**ZONING AND PLATTING COMMISSION SITE PLAN REVIEW SHEET
ENVIRONMENTAL VARIANCE REQUEST ONLY
REVIEW SHEET**

CASE: SP-2011-0051D

PROJECT NAME: Judge's Overlook

MEMORANDUM

PROPOSED CUT AND FILL EXHIBIT

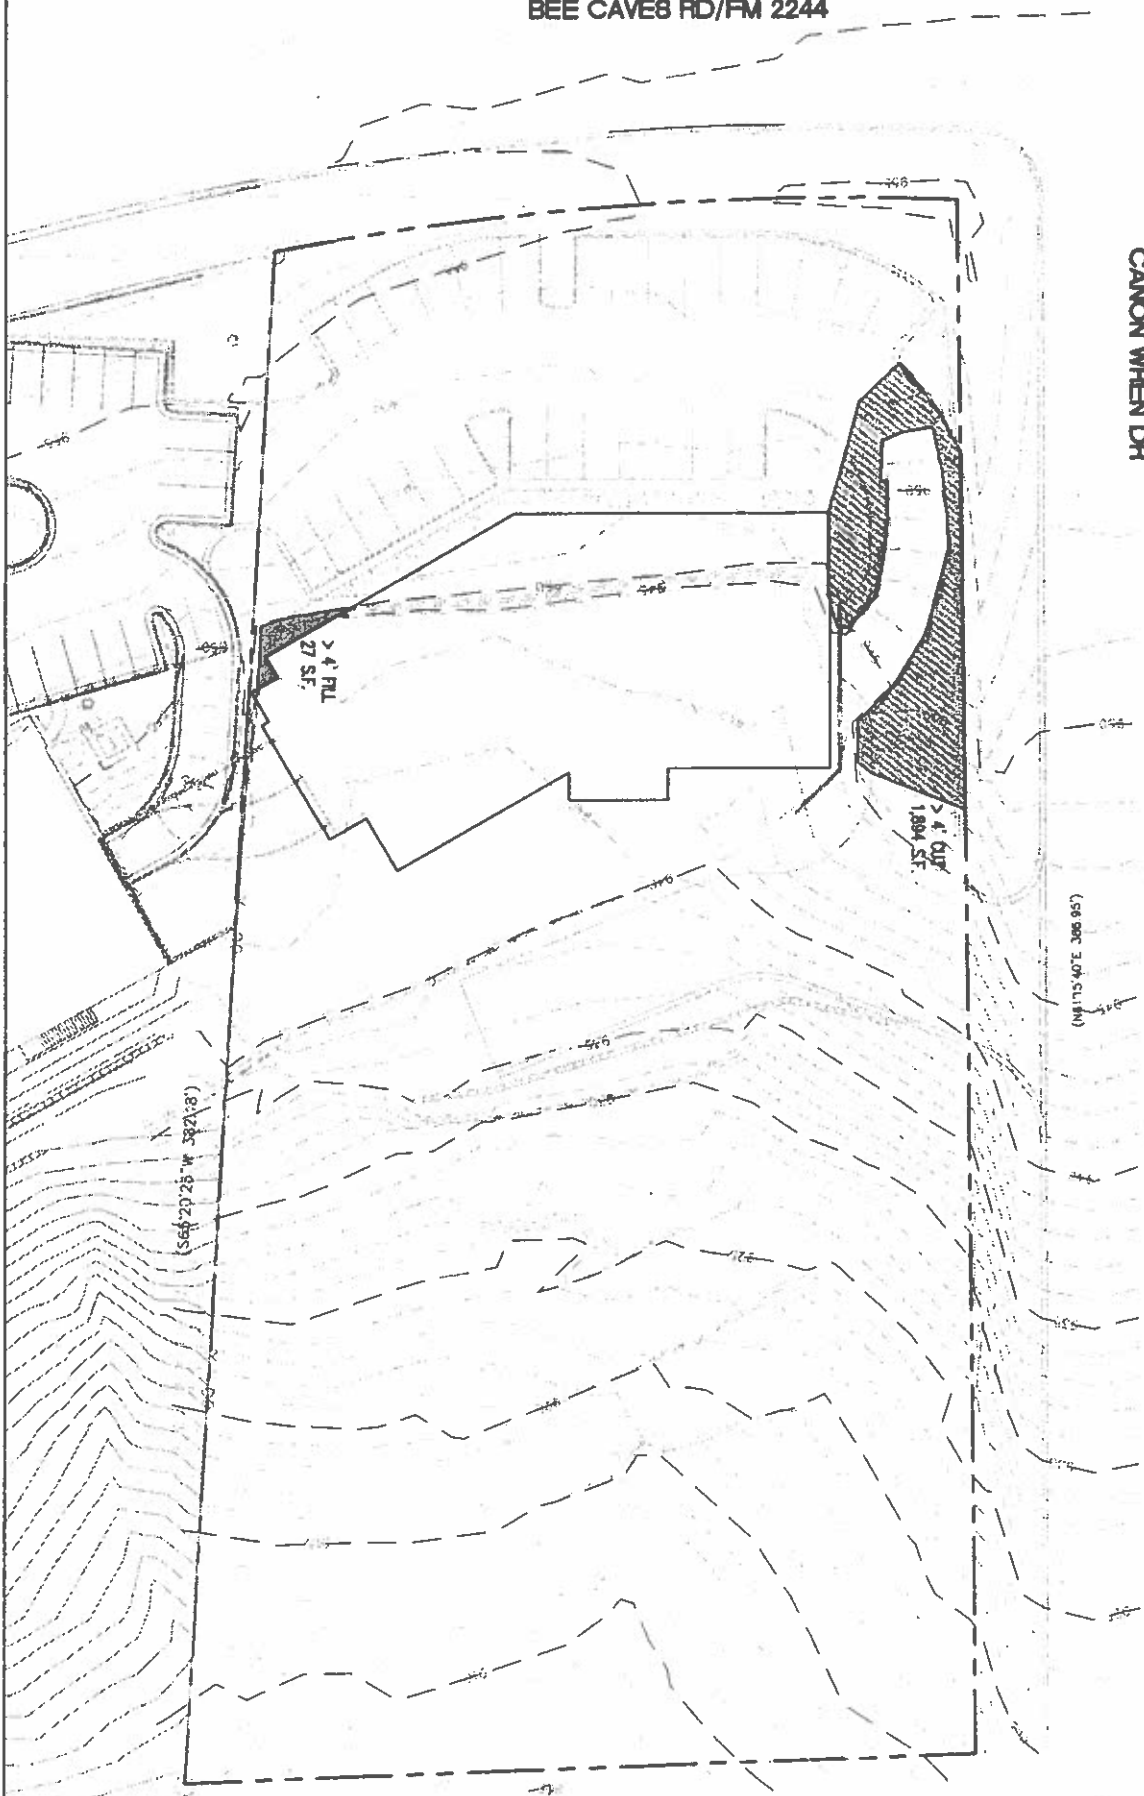
Along the southeast corner of the proposed building, an area of approximately 27 square feet will be filled more than 4 feet. Filling this area is necessary for pedestrian safety. Along the western side of the proposed building, an area of approximately 1,894 square feet (which represents less than 3% of the site) will require a cut greater than 4 feet in order to access the upper portion of the site from the driveway on Canon Wren. TxDOT requires that the site is accessed from Canon Wren.
